PLOT 49 - GROUND FLOOR FLAT PLOT 50 - MAISONETTE

DESCRIPTION OF CHANGES

West Elevation

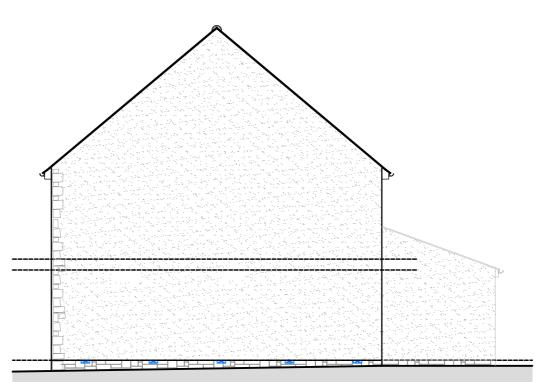
- Front elevation changed to all be natural stone.
- South elevation changed from brick to render.
- East Elevation changed to all render.
- Brickwork plinth omitted.Side elevation small windows at gable
- level omitted.
- Rear elevation brick arch window heads omitted.
- Ground floor maisonette entrance door moved to North Elevation.
- Long porch covering front elevation omitted and replaced with individual plot porches.
- Ground floor oriel window omitted.
